CUSTOMER : M/s. APTRANSCO	Design checked by	SCHEMATIC DIAGRAM 38 kV, 7.2 MVAR, 3 PH, CAPACITOR BANK	HITACHI ENERGY DRAWING NO.:	Rev	Scale	
					Drawing checked by			YC1H423188-002	0	NTS
					Drawn by				© Hitachi Energy	1
Rev	Revision	Appd	Year Week	Iss by Dept	Year Week	Cont.

Design checked by: VK	LAYOUT DRAWING OF 38 kV, 7.2 MVAR, 3 PH, CAPACITOR BANK	HITACHI ENERGY DRAWING NO.: YC1H423188-050
Drawing checked by: SK		
Drawn by: HKR

CUSTOMER : M/s APTRANSCO	Design checked by: VK	SUPPORT STRUCTURE FOR 38 kV, 7.2 MVAR	HITACHI ENERGY DRAWING NO.:	Rev	Scale
			Drawing checked by : SK	3 PH, CAPACITOR BANK & NCT.		00	NTS
			Drawn by : HKR		Iss by Dept PGHV-C		Sheet
					Year Week 24 06		1 OF 4
Rev	Revision	Appd	Year	Week	YC1H423188-080		Cont.
							2 OF 4

8534178/2024 SHEET ENDS  
This drawing is property of QUALITY POWER ELECTRICAL EQUIPMENTS PVT.LTD. It is submitted as confidential in connection with our enquiry/order. It is not to be used for any other purpose nor may it be copied or lent without our written permission.

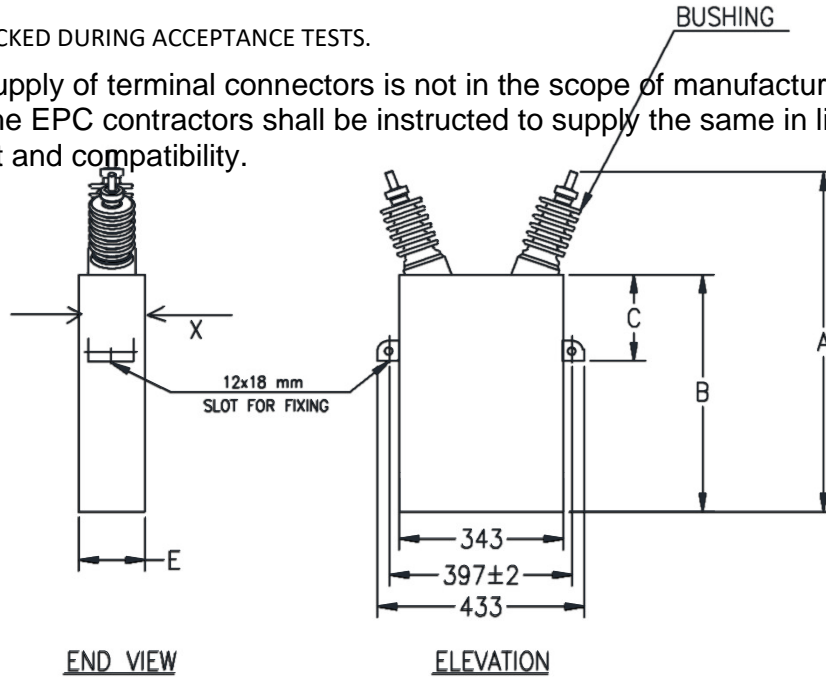
NOTE : DRAWING APPROVAL SUBJECT TO VALID TYPE TEST REPORTS.

TO BE CHECKED DURING ACCEPTANCE TESTS.

Since the supply of terminal connectors is not in the scope of manufacturer as mentioned in the drawings, the EPC contractors shall be instructed to supply the same in line with CT/IVT/CVT requirement and compatibility.

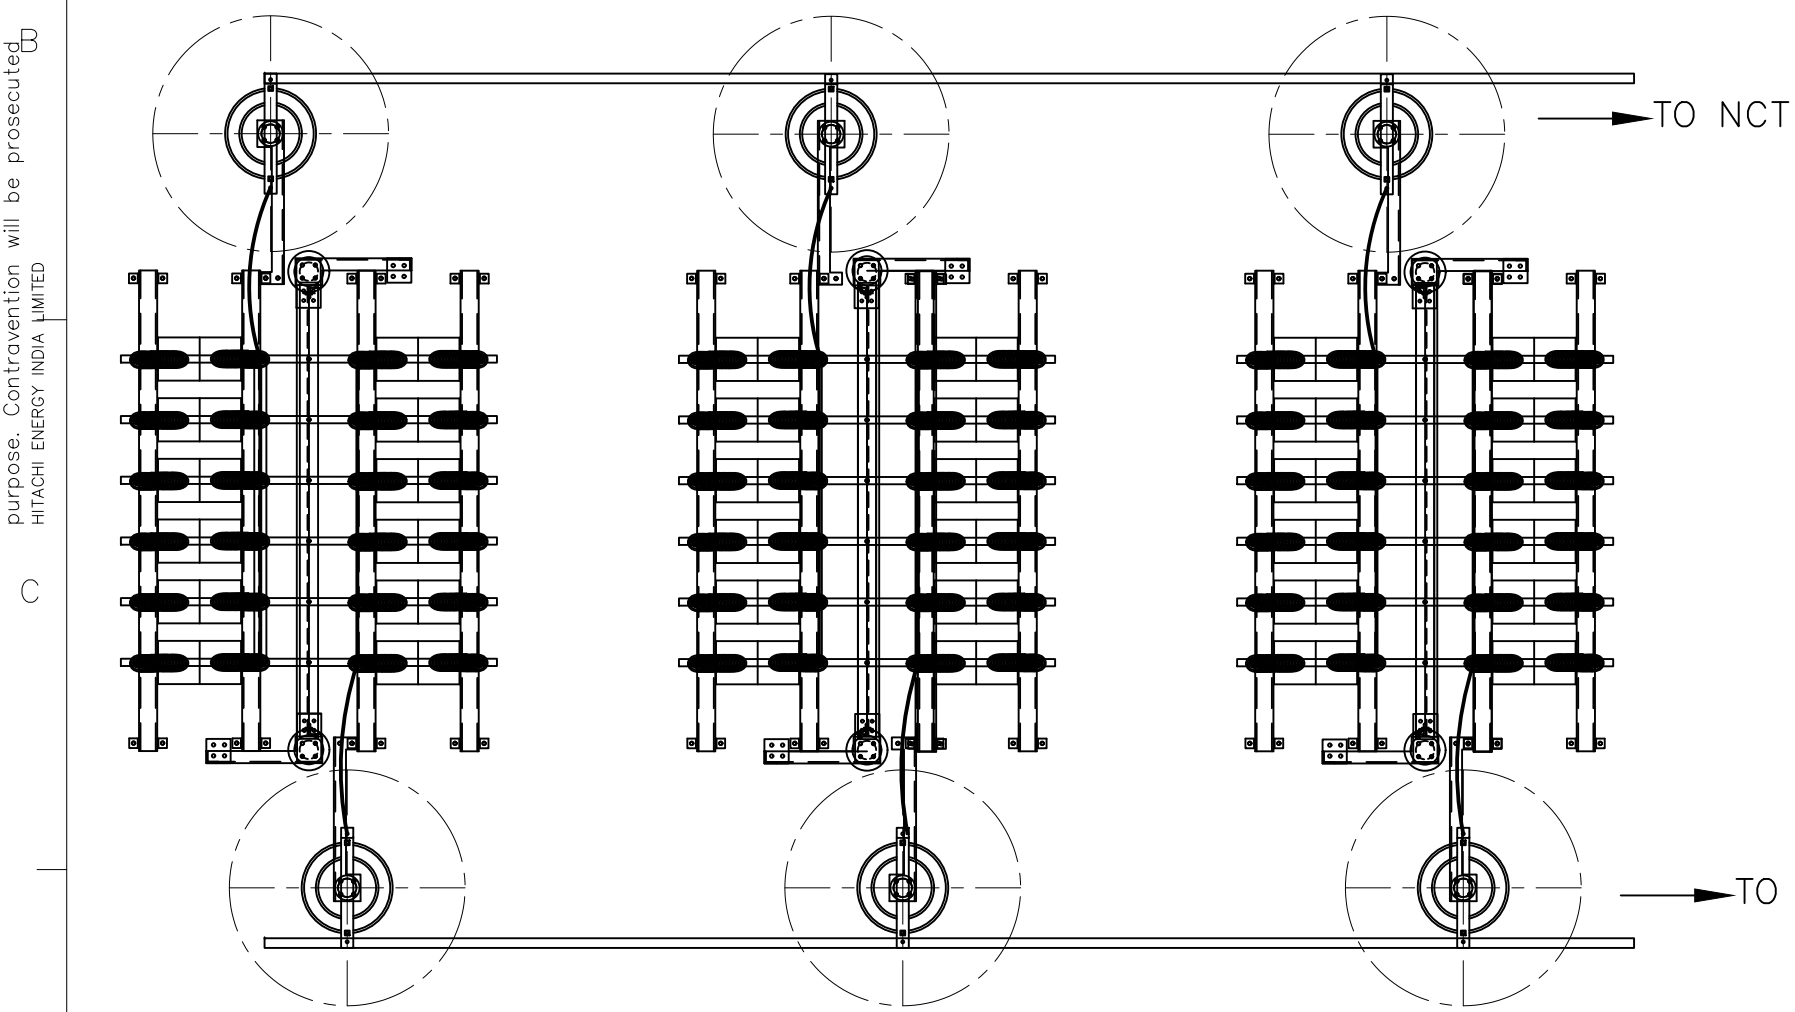
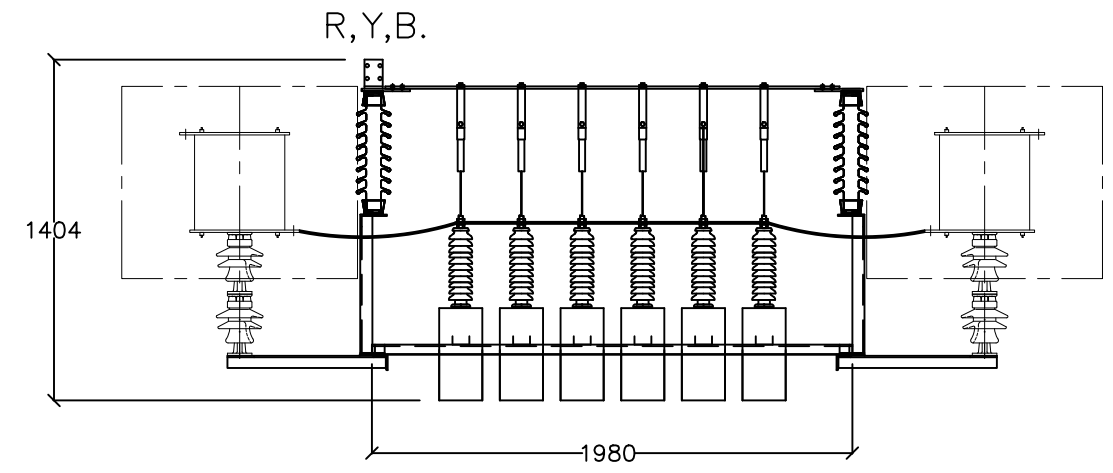
NOTE : DRAWING APPROVAL SUBJECT TO VALID TYPE TEST REPORTS.  
TO BE CHECKED DURING ACCEPTANCE TESTS.

Drawing approval subject to valid vendor registration

Since the supply of terminal connectors is not in the scope of manufacturer as mentioned in the drawings, the EPC contractors shall be instructed to supply the same in line with CT/IVT/CVT requirement and compatibility.

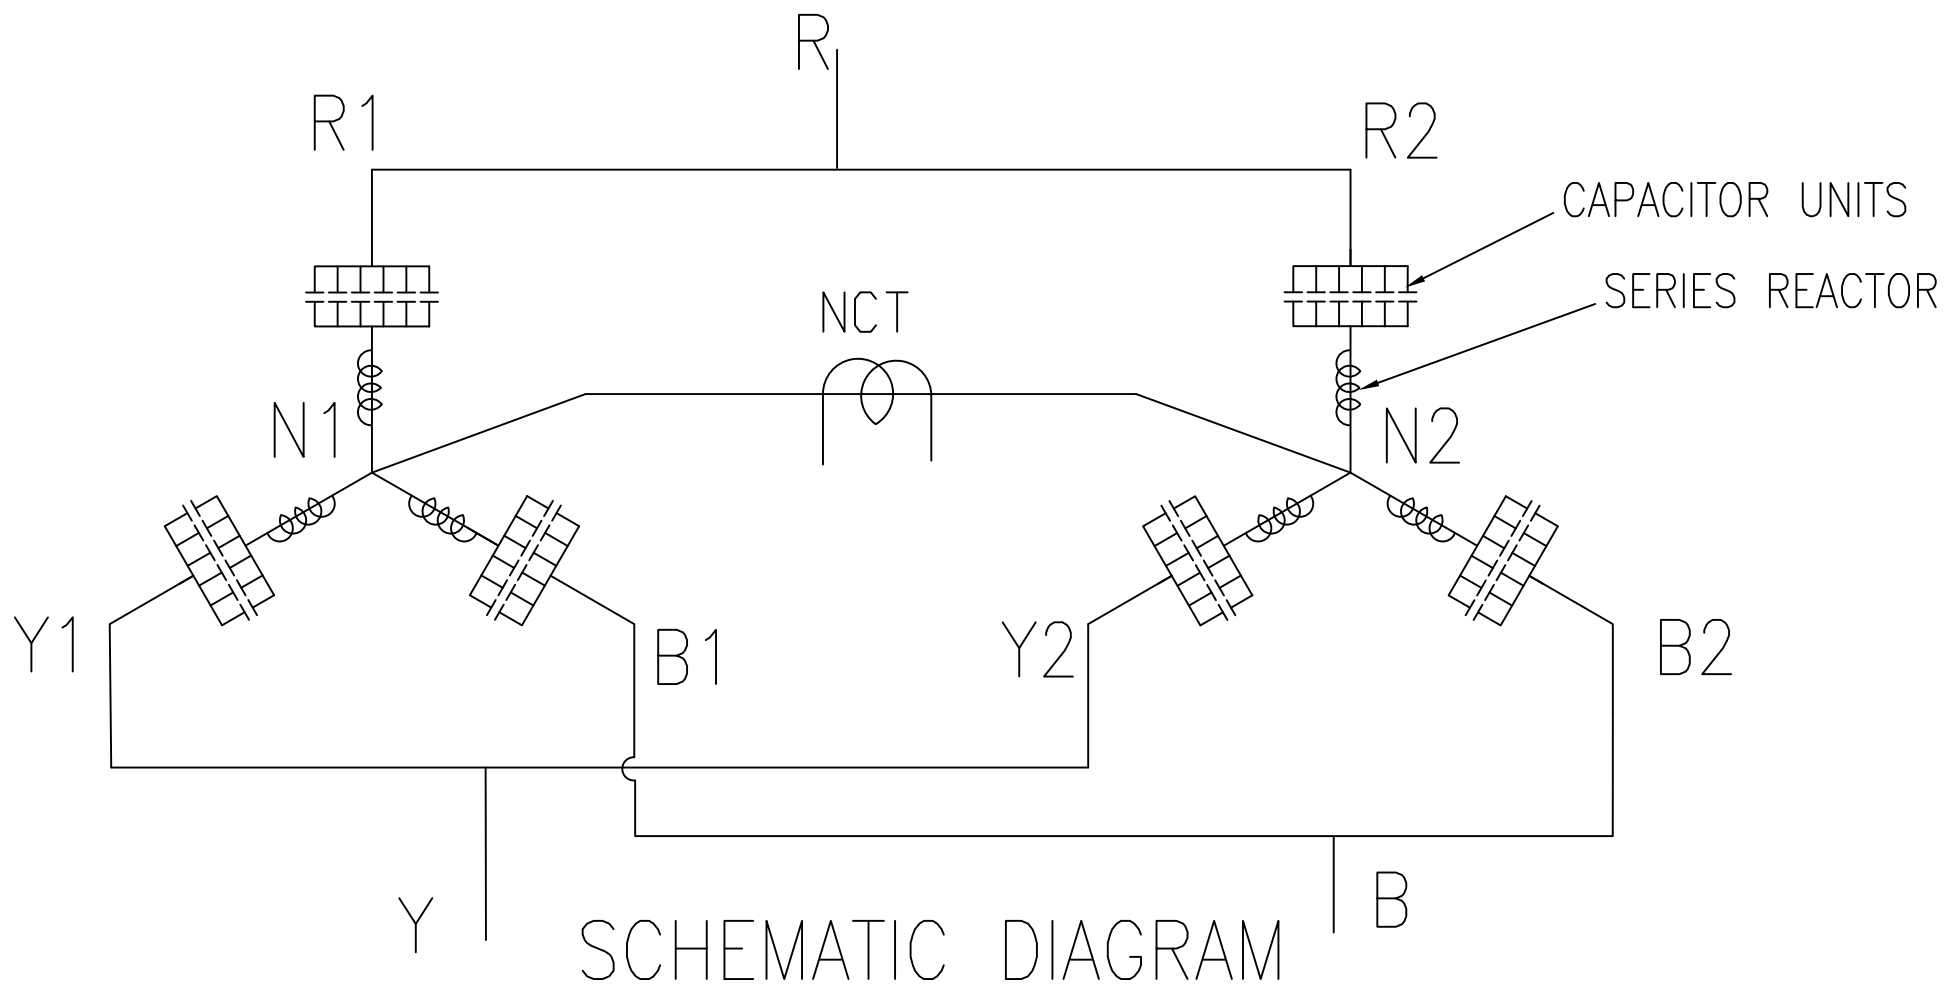
NOTE : DRAWING APPROVAL SUBJECT TO VALID TYPE TEST REPORTS.  
TO BE CHECKED DURING ACCEPTANCE TESTS.

Since the supply of terminal connectors is not in the scope of manufacturer as mentioned in the drawings, the EPC contractors shall be instructed to supply the same in line with CT/IVT/CVT requirement and compatibility.

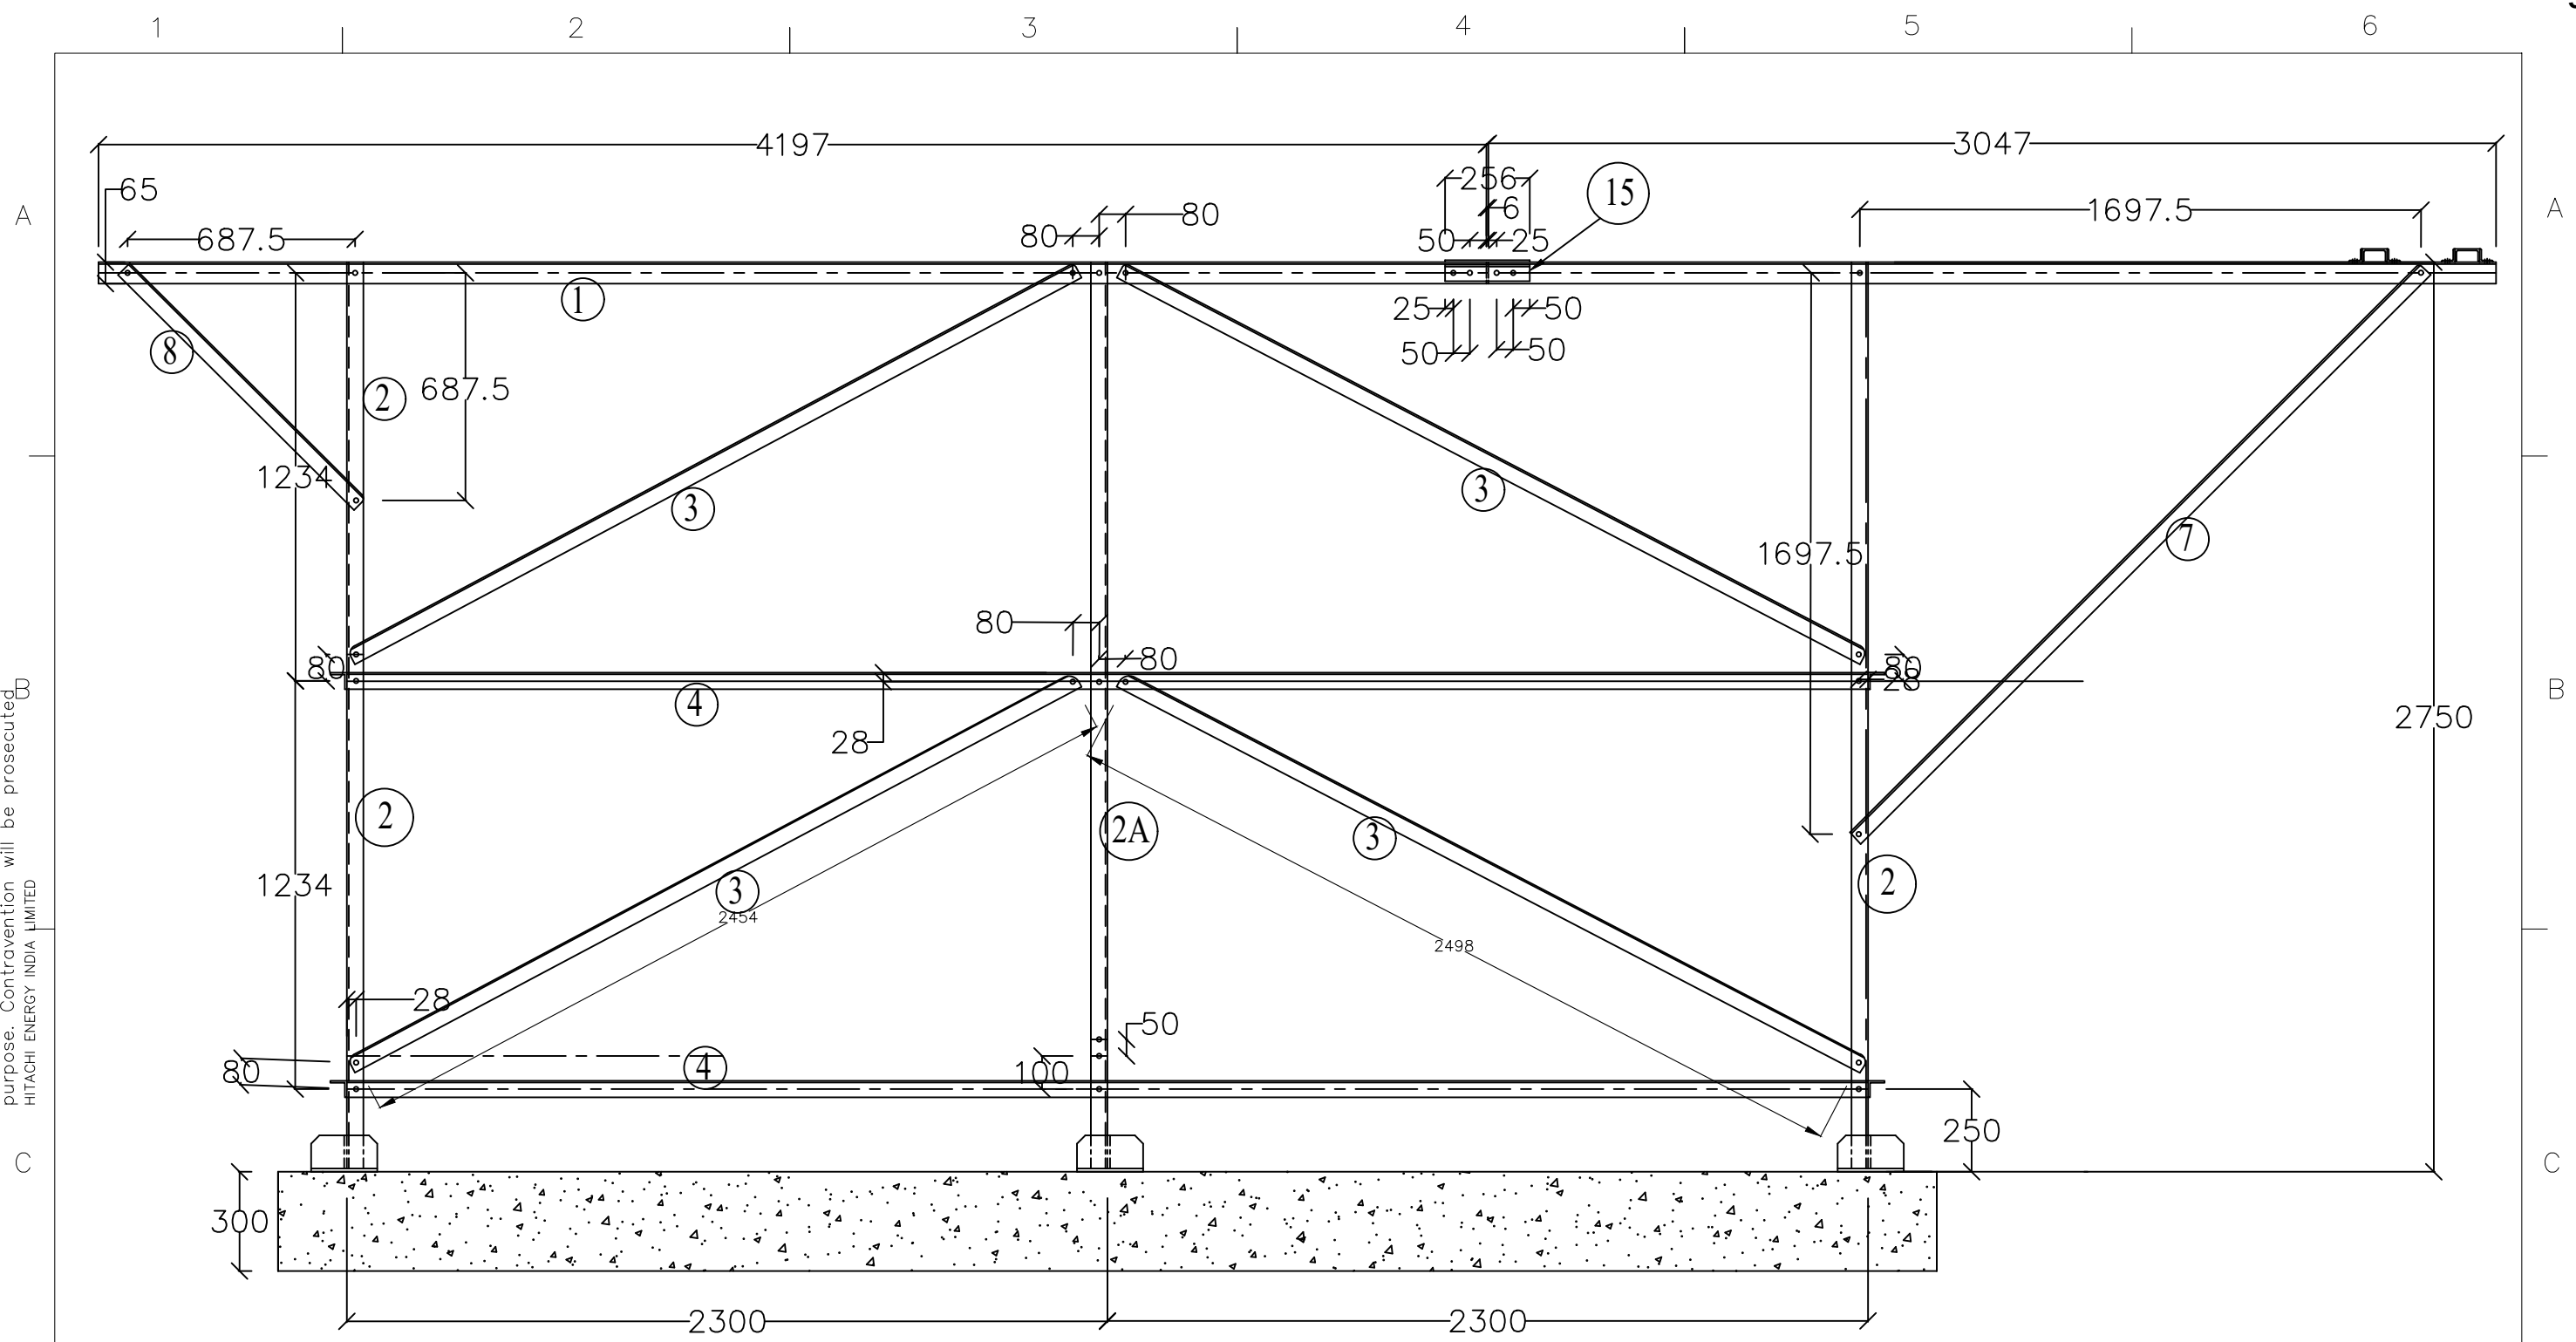
1) Minimum 300mm plinth shall be maintained for CT/PT/CVT/Isolators in the substation during foundation works to ensure safe live to ground clearances as per IE rules.

2) Since the supply of terminal connectors is not in the scope of manufacturer as mentioned in the drawings, the EPC contractors shall be instructed to supply the same in line with CT/PT/CVT/Isolators requirement and compatibility.
